ROCHIE'S 9X'TRA NEWS LETTER

VOL. 1 NO. 3

C O N T E N T S

OLDSMOBILE, 1956—NEW CARBURETOR FOR RACING APPLICATIONS. Model 4-GC, Part No. 7009775

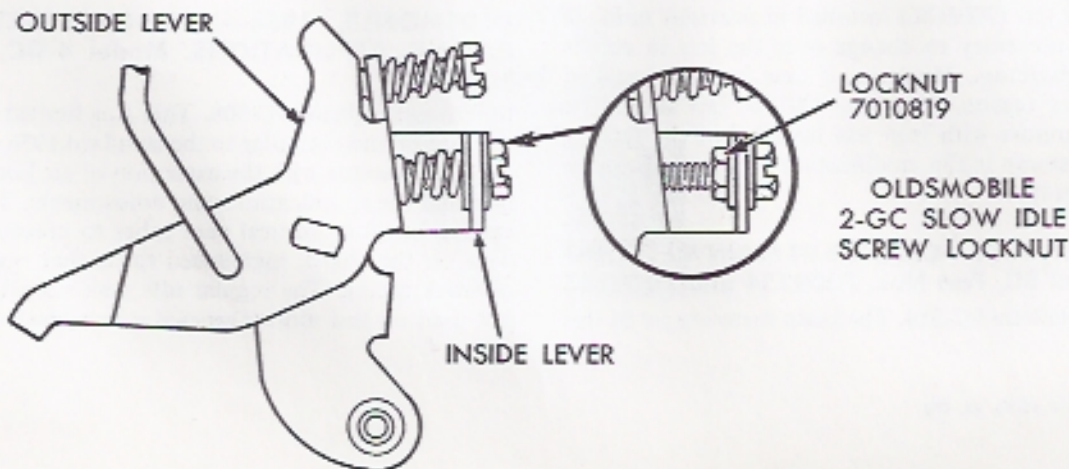
Reference: Bulletin 9C-508. This is a limited-production carburetor and is similar to the standard 1956 Oldsmobile 4-GC carburetor with the exception of air horn construction and the specifications and adjustments. The air horn casting has four vertical vent tubes to prevent fuel spill-over on the sharp, high-speed turns that occur in road or track racing. The regular idle vent valve (7004527) is not used on this unit. (Continued on next page.)

through Oldsmobile dealers. *Specifications and adjustments for the 7009775 carburetors are as follows:*
